SUBJECT: Forwards responses to Geosciences Branch 810504 second round questions re neotectonic models or alternative models of Columbia Plateau. Final draft of FSAR Sections 2.5.1 & 2.5.2 will be submitted as Amend 18 on or about 811020.

Subject: SUPPLY SYSTEM NUCLEAR PROJECT NO. 2
RESPONSES, GEOSCIENCES BRANCH TO ROUND TWO
QUESTIONS AND FINAL DRAFT OF FSAR SECTIONS 2.5.1 and 2.5.2

Reference: Letter, R. L. Tedesco to R. L. Ferguson, "WNP-2 FSAR -
Request for Additional Informaion," dated May 4, 1981.

Figure
361.6-1

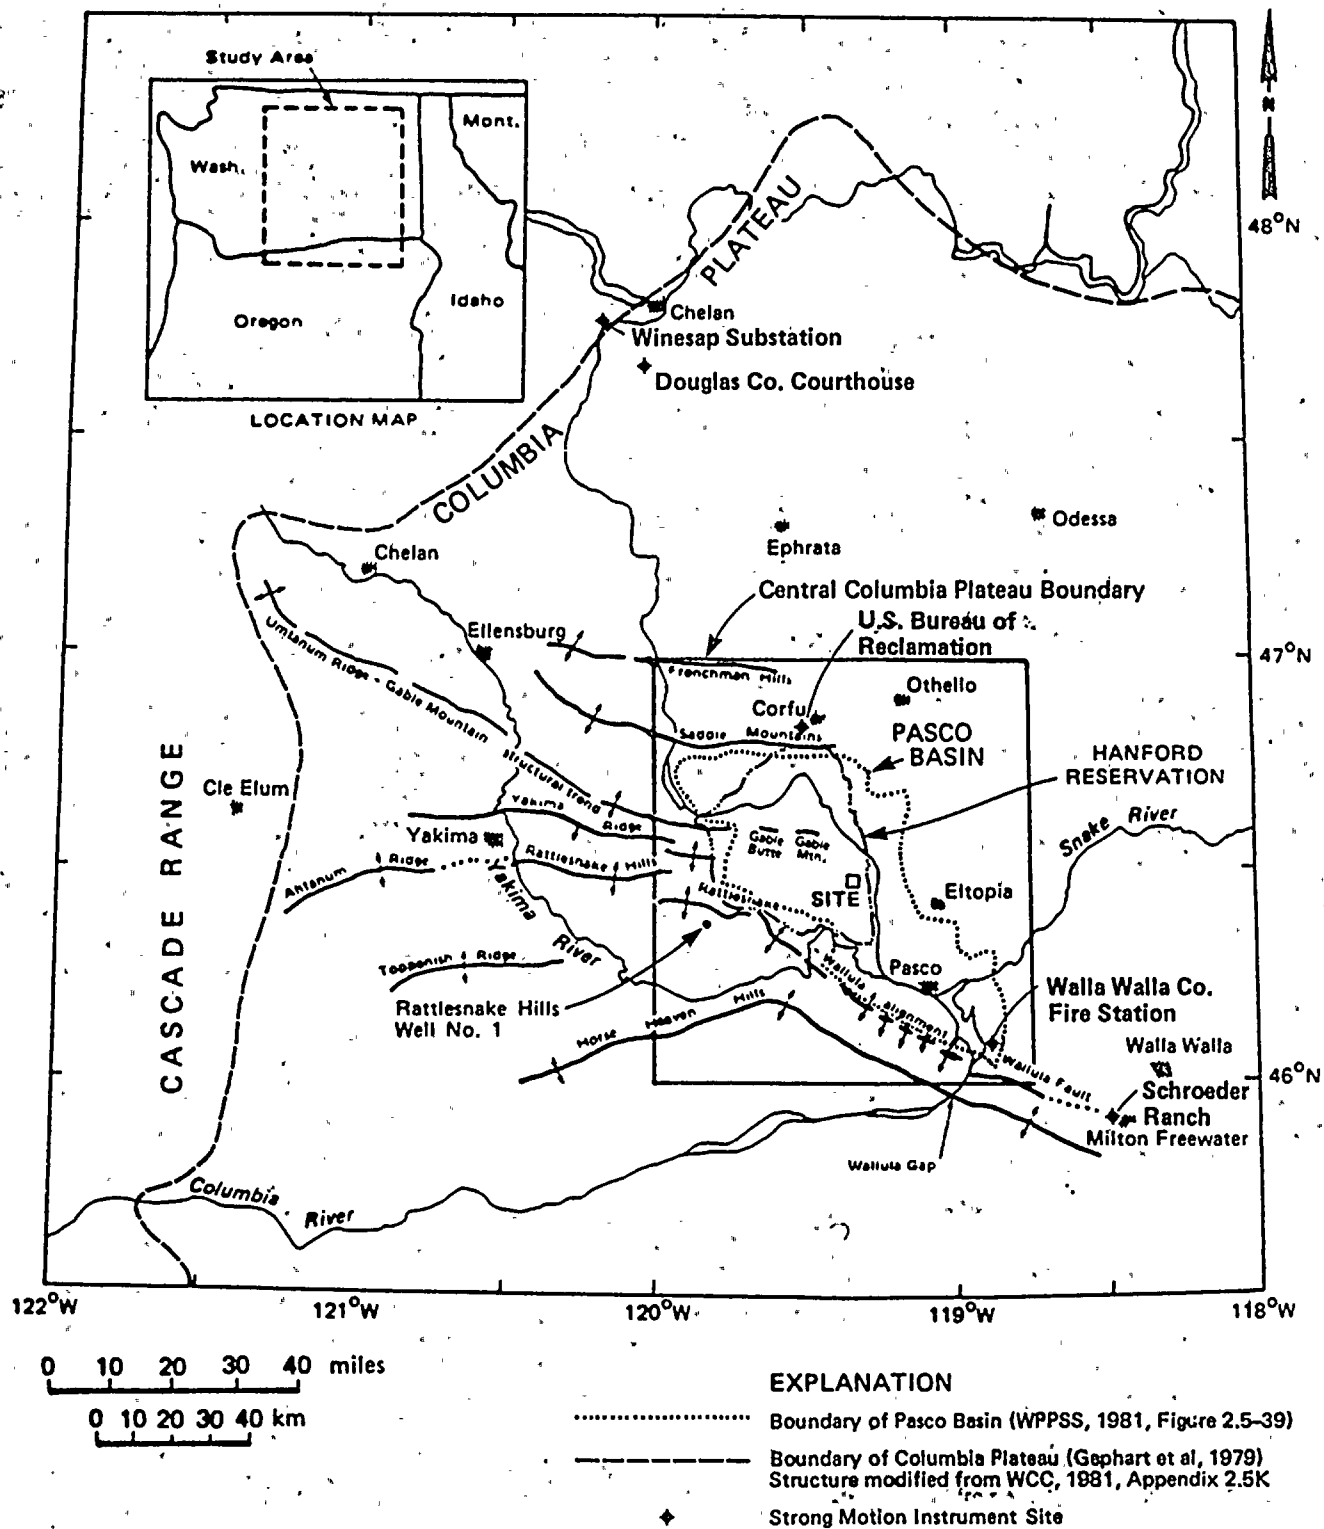
Provide the location and dates of operation of the strong motion instruments mentioned in your January 27, 1981, work plan.

The location and dates of installation of the strong motion instruments mentioned in the Supply System's January 27, 1981, work plan are as follows:

<u>Station</u>	<u>Latitude</u>	<u>Longitude</u>	<u>Date of Installation</u>
Schroeder Ranch	45°57'	118°24'	September 3, 1981
Walla Walla Co. Fire Sta.	46°05'	118°54'	September 2, 1981
U.S. Bureau of Reclamation Communications Building	46°11'	119°33'	To be installed
Douglas County Courthouse	47°39'	120°04'	To be installed
Winesap Substation Chelan Co. P.U.D.	47°42'	120°13'	To be installed

These locations are shown on Figure 361.6-1.
